**Historical Architectural Review Board  
COA Final Review Sheet**

**HDC-2023-00061**

**Address: 631 W. Allen Street**

**Proposal: Enlarge rear dormer**

**Front and side façades of 631 W. Allen Street, 2023.  
(Google StreetView)**

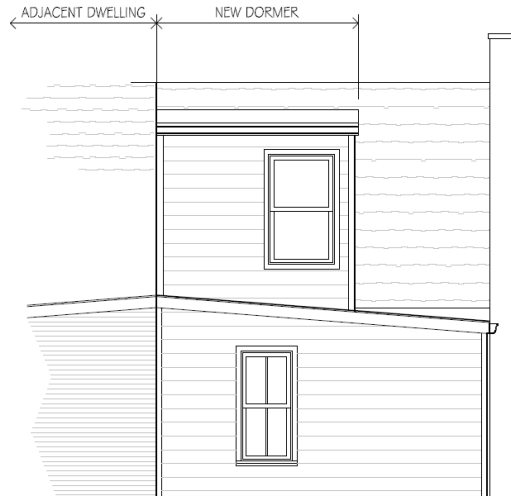
When the application was received, staff notified the applicant that a violation had been issued in 2020 for painting the first-story brick at the front and Morris Street facades. Staff had pursued the violation with the previous owner for several years, but was unable to resolve the issue. The violation remains open and would require a second application either to the staff or the HARB. Staff recommends removing the paint from the masonry.

The HARB commented that Mr. Lewis inherited a problem with the painted brick and will need to remove it. Mr. Lewis responded that he would attempt to remove the paint.
